City of Sebastopol Design Review Board Staff Report

Meeting Date: March 3, 2021
Agenda Item: 8A
To: Design Review Board
From: Alan Montes, Associate Planner
Subject: Design Review for Oxygen Storage Tanks
Recommendation: Conditional Approval
Applicant/Owner: James Loera/Gurpreet Singh
File Number: 2021-001
Address: 6789 Walker Ave.
CEQA Status: Categorical Exemption: Section 15303: Class 3
General Plan: Commercial Office (CO)
Zoning: Commercial Office (CO)

This is a design review application for the installation of oxygen storage tanks and screening in the parking lot located 6789 Walker Ave. to serve Sebastopol Specialty Hospital.

A-201

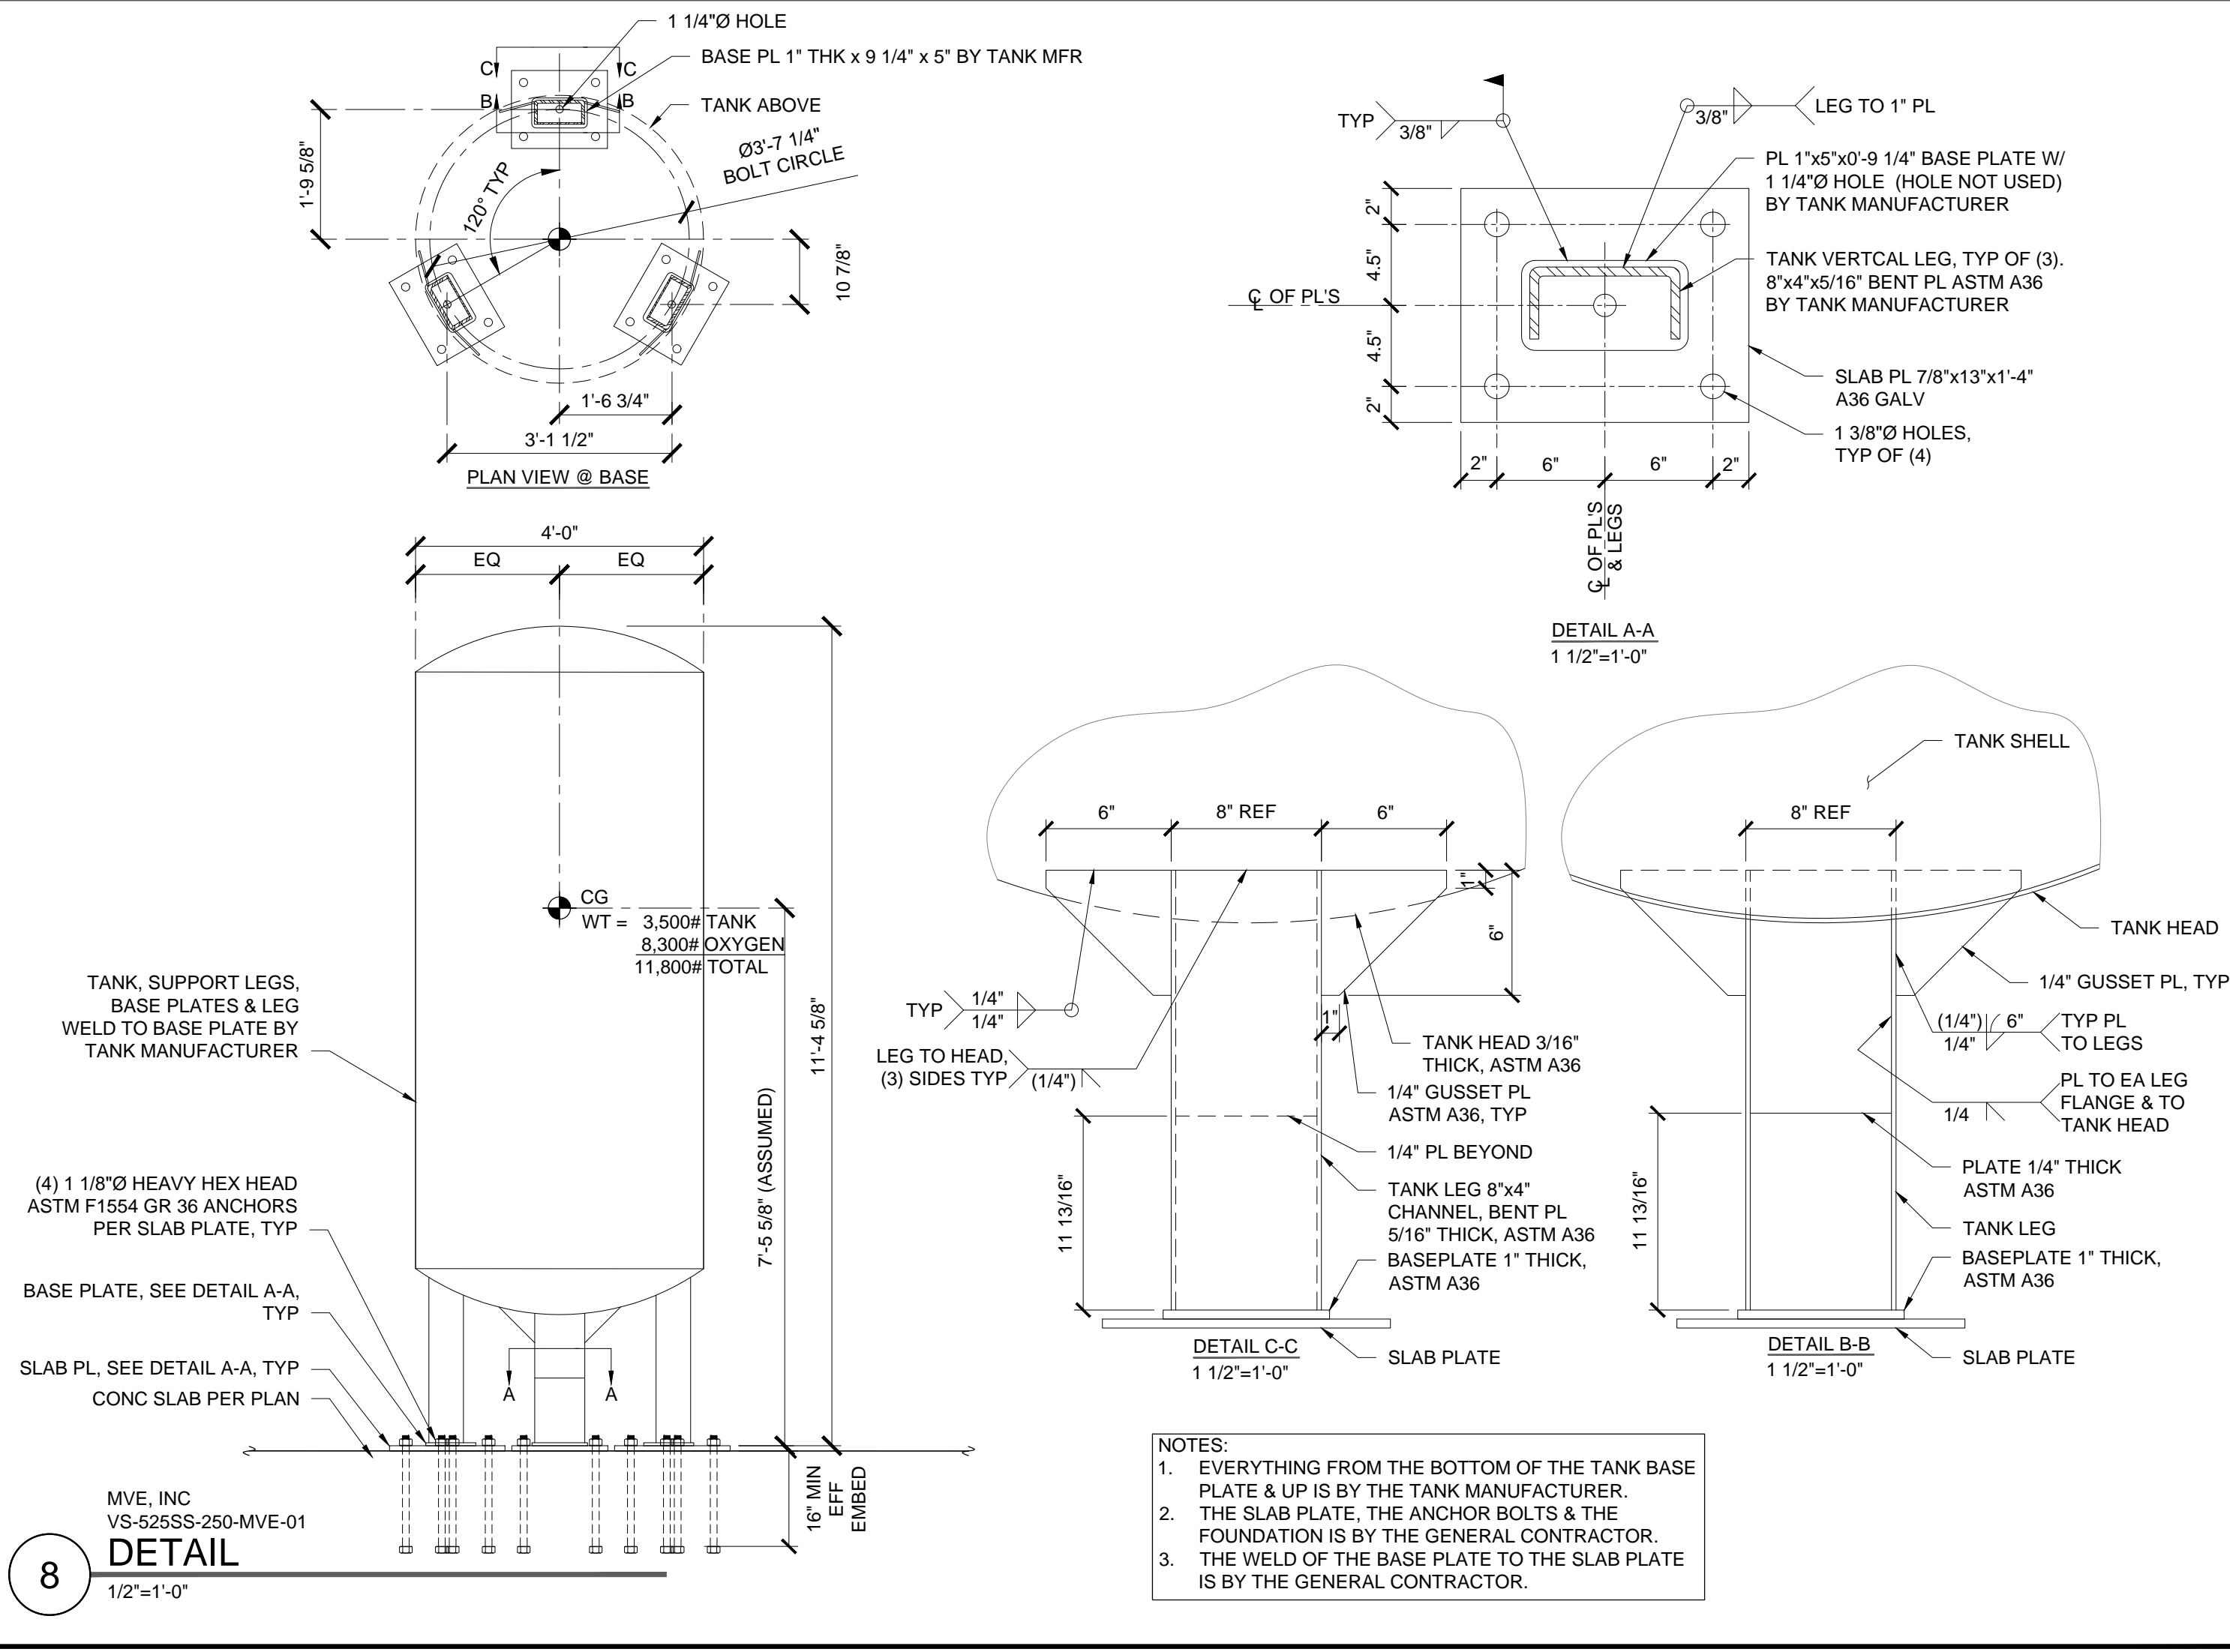
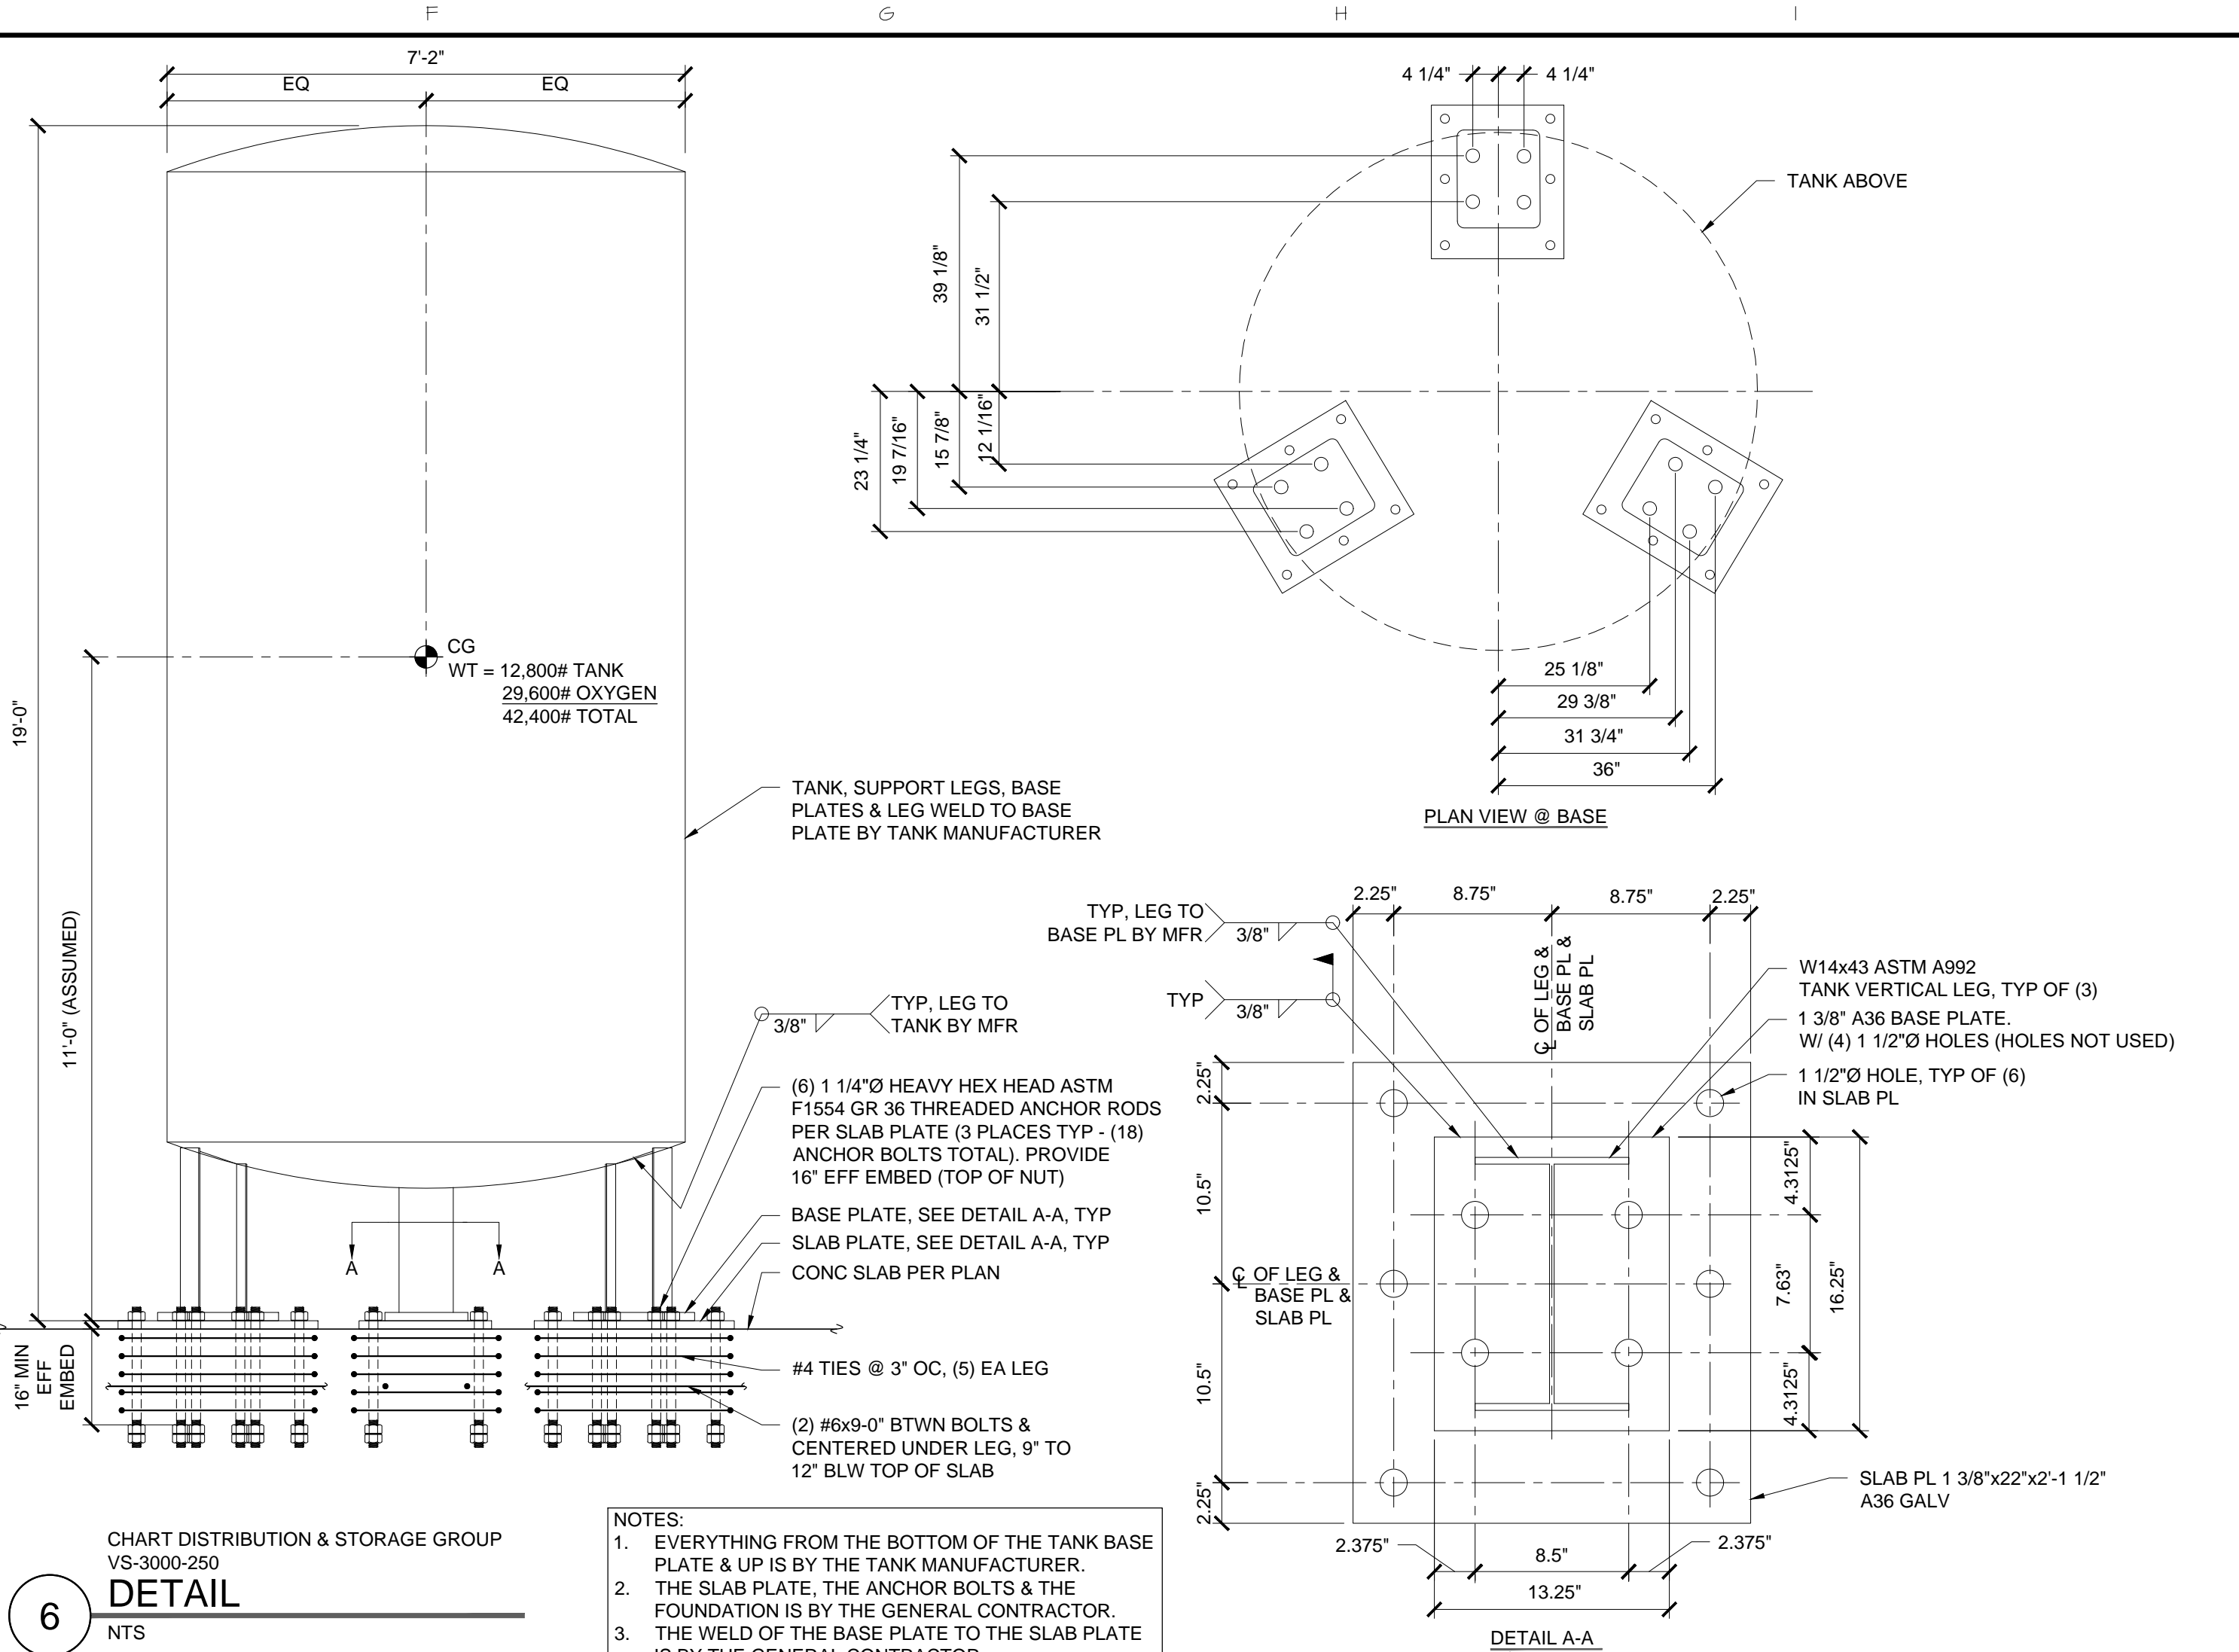
There is concern regarding the height of the structure and the screening material (chain link fence with slats). The storage tank does exceed the accessory structure height limit, but there is an exception to exceed the height limit by up to five feet for gas storage tanks. The project proposes a seven-foot chain link fence with slats around the equipment. The fencing will provide a partial screen along with the existing landscaping. Given that the equipment is located uphill from the right of way, staff anticipates minimal visual impacts from the street.

Staff is seeking the Board's input on whether a higher quality fence and/or a landscape island with root barriers should be added to the west of the equipment to better screen the equipment. The applicant has stated that oxygen yards typically utilize chain link fencing or CMU block walls for screening as they are non-combustible materials. Alternatively, if the Board is supportive of a chain link fence with slats, does the Board have a preferred color for the slats.

Thanks for getting this over to me. I had a chance to review the plans and given the overall height of the structure this will require the Design Review Board's review and approval. I apologize for the confusion, when we first spoke, without viewing plans, I was foreseeing a much smaller structure that could be entirely screened and in a less visible location.

1. Elevations showing the tanks + structures with the fence around it.
2. # of beds in the hospital
3. Fee = \$535 (I can take this in today over the phone, please confirm a time to call in via email)

Hi Alan – here are the elevations – sheet A-201 attached. Please note that the previous oxygen tank for the facility was at the SE corner at bottom of hill on access road around back. In 2015 they replaced the tank with large cylinders because the oxygen vendor trucks were not able to access that road. They could only provide the cylinders. They are having shortages with this capacity, especially in light of the COVID pandemic and added need for ventilators. The location selected for this project is the further “back” we could put this tank, and still have it accessed by the vendor’s supply trucks.
